3-E-26-SU  
2/25/2026

LOT PLAN OF:  
Lots 1R-R1 & 1R-R2, Resub. of Lot 1R, Block C, Glenwood Park Addition & Lot 20R, Final Plat of Lots 1, 2, 3, 4, 19, 20 & 21 Block C, Glenwood Park Addition  
Ward 43, City Block 43320, Knoxville, Tennessee

**PROJECT INFORMATION**  
 New Two Family Dwelling Modern  
 3-Bed 3-Bath 5305 Jackshoro Pike  
 Knoxville, Tennessee  
 Contractor: Braden Family Properties  
 Phone: (865) 696-7343  
 ID: 2FM2ST3BD3RCSR  
 Drawn By: ASOF Custom Plan Service  
 Project: 2023-0423  
 September 16, 2023

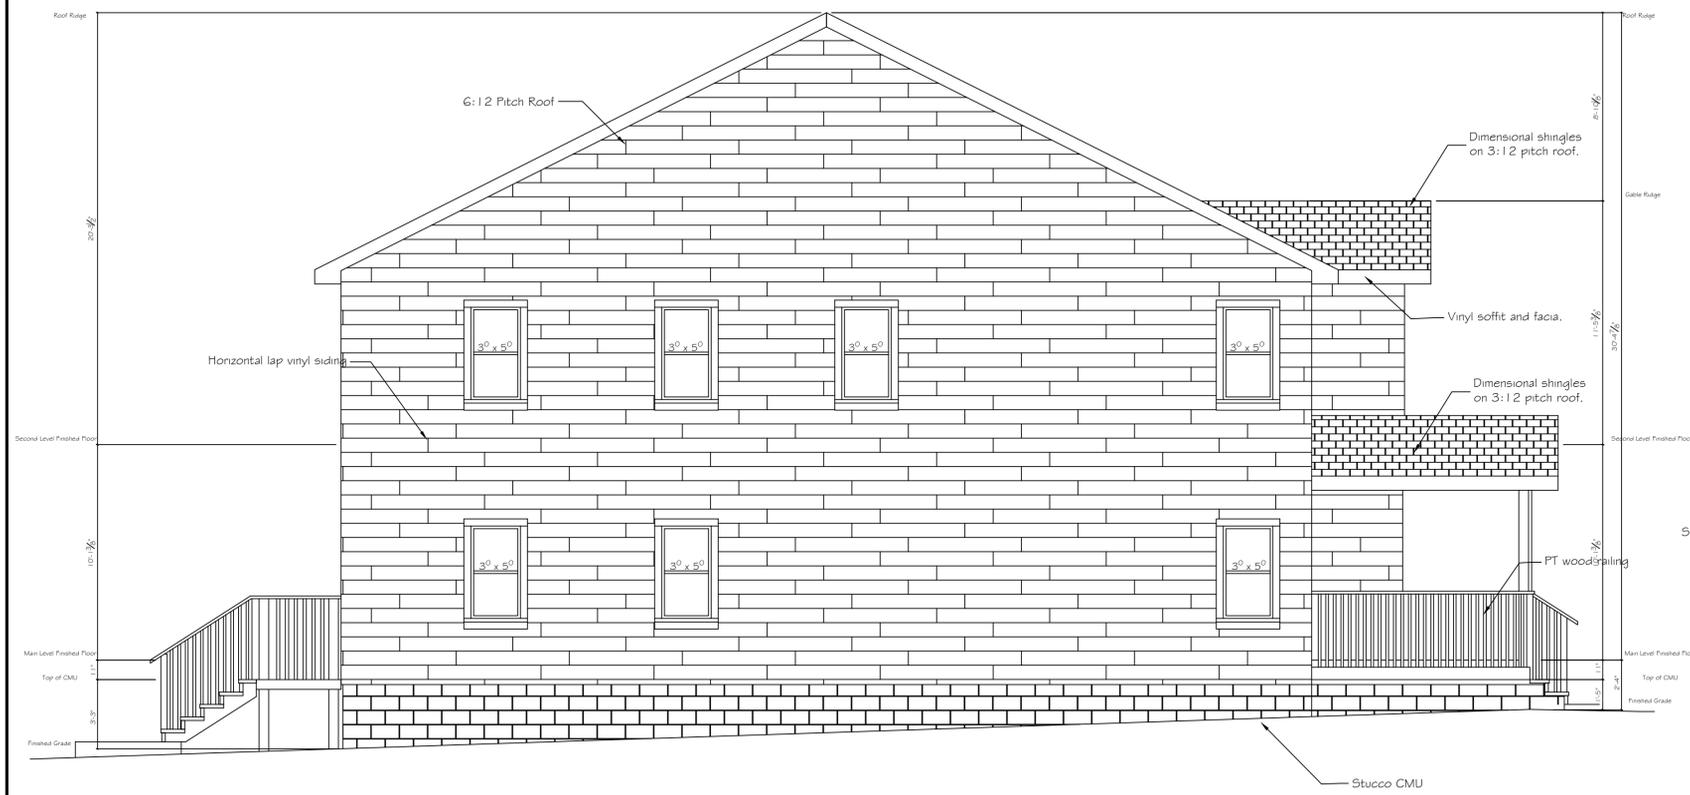
- ENGINEERING PLANNING REVIEW COMMENTS**
- DRIVEWAYS MUST BE SEPARATED, AT A MINIMUM, BY THE WIDTH OF THE WIDER DRIVEWAY.
    - THE MAXIMUM DRIVEWAY WIDTH FOR THESE LOTS IS 20 FEET. THIS APPLIES TO ALL PARKING AND DRIVING AREAS IN THE FRONT OR CORNER SIDE YARD.
  - THE FOLLOWING COMMENTS CONCERNS LOTS 1R-R1 AND 1R-R2
    - THE MAXIMUM DRIVEWAY WIDTH FOR THESE LOTS IS 20 FEET. THIS APPLIES TO ALL PARKING AND DRIVING AREAS IN THE FRONT OR CORNER SIDE YARD.
  - THE FOLLOWING COMMENT CONCERNS LOTS 20R
    - THE MAXIMUM DRIVEWAY WIDTH FOR THESE LOTS IS 25 FEET. THIS APPLIES TO ALL PARKING AND DRIVING AREAS IN THE FRONT OR CORNER SIDE YARD.

**RESPONSE TO COMMENTS 2 AND 3**

**Driveway and Parking in Front Yard**  
City of Knoxville Zoning Code Article 2.3 Definitions  
**Driveway.** A pathway for motor vehicles from a street to a lot used only for service purposes or for access to the lot.

**Off-Street Parking.** The storage space for an automobile on premises other than streets or rights-of-way.  
Article 11 OFF STREET PARKING  
11.3- LOCATION AND SETBACKS

D. For single-family and two-family dwellings, parking is prohibited in the front and corner side yard except as follows:  
1. On approved driveways and in approved parking spaces

E. For single-family and two-family dwellings, approved parking and driveway(s) in the front and corner side yard are limited to the following:  
1. On lots with a carport or garage:

a. The driveway leading to a carport or enclosed garage, not to exceed the maximum width allowed, except for flares adequate to access the carport or garage.

b. A connector driveway may extend from a circular driveway to beyond the front wall of the structure. Connector driveways must comply with driveway width requirements.

2. On lots with no carport or garage:  
a. With lot frontage of 75 feet or less, the driveway must be within ten feet of the side lot line.  
Table 11-2: Required Off-Street Parking  
Dwelling—Two-Family: 2 per du

11.6- DESIGN OF OFF-STREET PARKING FACILITIES  
A. All areas devoted to off-street parking must be designed so that no vehicle is required to back into a public street or alley to obtain ingress or egress, except for the following:

1. Off-street residential parking for single-family, two-family, and townhouse dwellings when the lot is accessed from a local street or alley.  
Table 11-7: Driveway Width and Curb Cut Length Standards  
Single-Family, Two-Family & Townhouse: By Lot Width  
Driveway Dimension Length of Curb Cut  
Min. Max. Min. Max.  
50 feet or less 10' 18' 15' 24'  
> 50-74 10' 20' 15' 28'

**DRIVEWAY AND PARKING CLARIFICATION NOTE**  
THE DRIVEWAYS SHOWN HEREON REPRESENT THE ACCESS POINTS FROM THE PUBLIC RIGHT-OF-WAY TO THE PROPOSED DWELLING UNITS.  
PER THE CITY OF KNOXVILLE ZONING CODE, DRIVEWAYS AND PARKING AREAS ARE REGULATED UNDER SEPARATE ORDINANCES AND ARE DISTINCT IMPROVEMENTS.  
THE PARKING AREAS SHOWN HEREON ARE NOT CONSIDERED DRIVEWAYS AND ARE NOT INTENDED TO BE REGULATED AS DRIVEWAY ACCESS POINTS, LOCATIONS, OR WIDTHS.
